July 12, 2024

RE: Comments on “Kingston Mixed-Use Development” (Clean Water Act Section 404 Permit Application SAJ-2024-00967 (SP-SJF)); Request for Public Hearing

Exhibit A

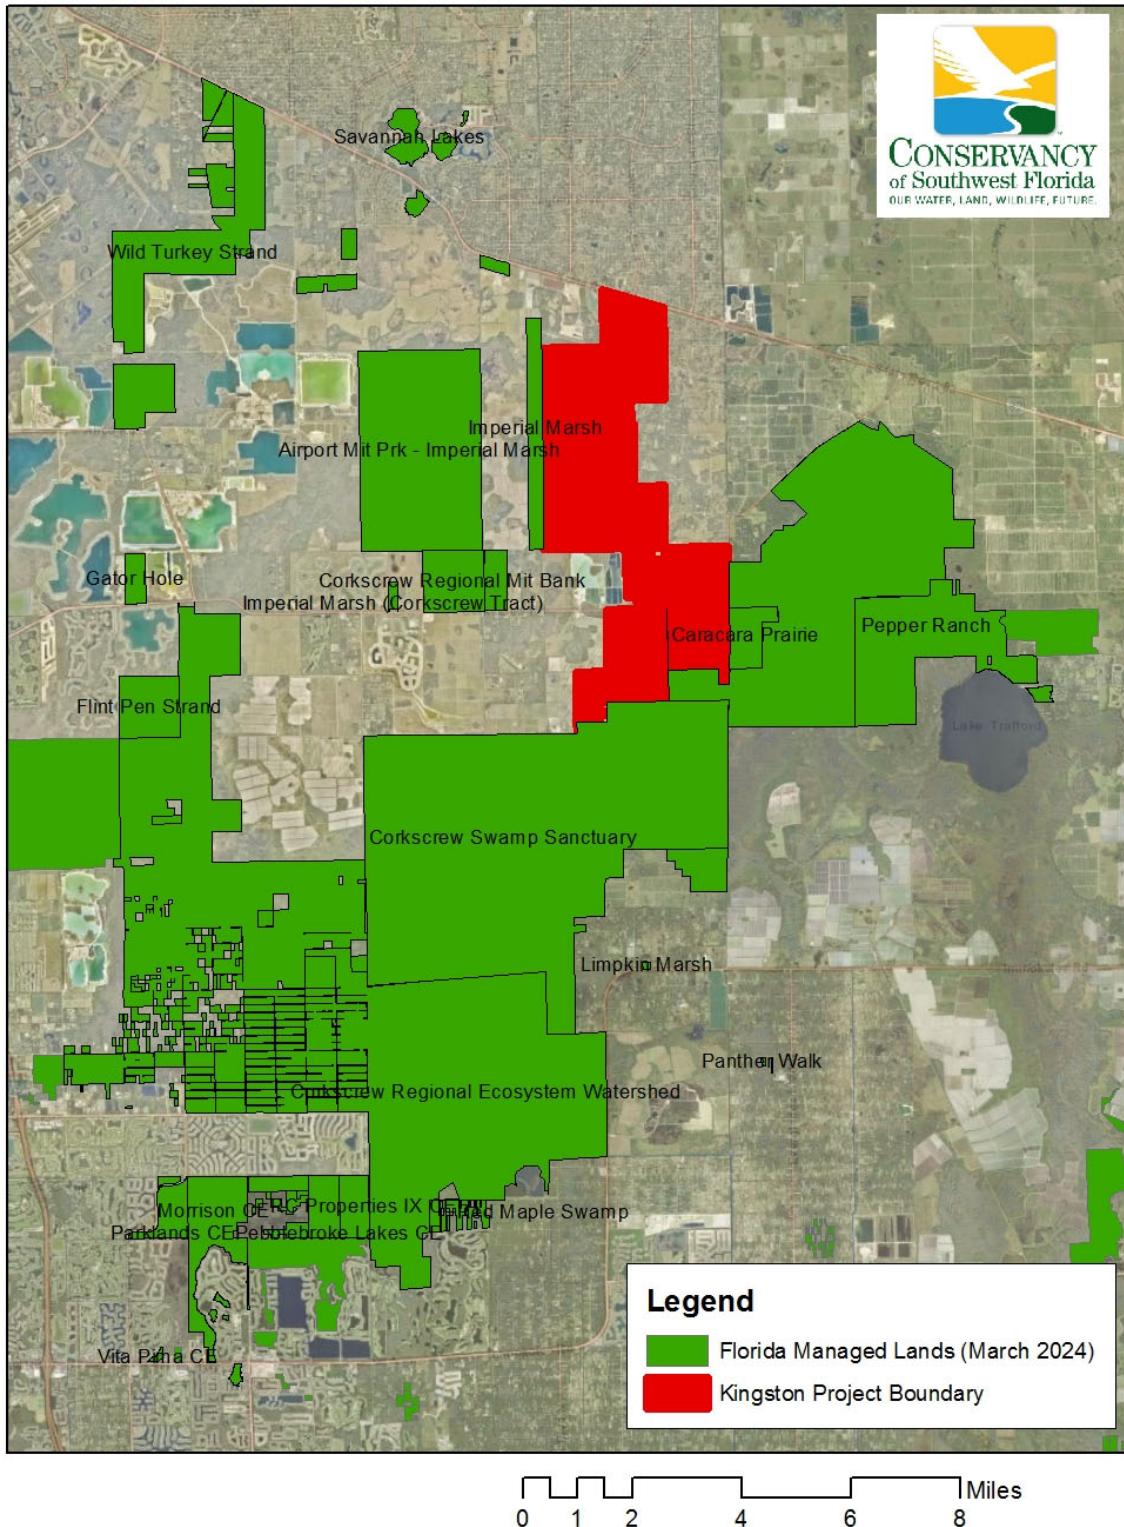
²²⁸ See Exhibits A and B below – Figures prepared by Conservancy of Southwest Florida. Exhibit A shows the locations of state managed lands. Figure B shows the locations of the protected and conservation lands discussed here.
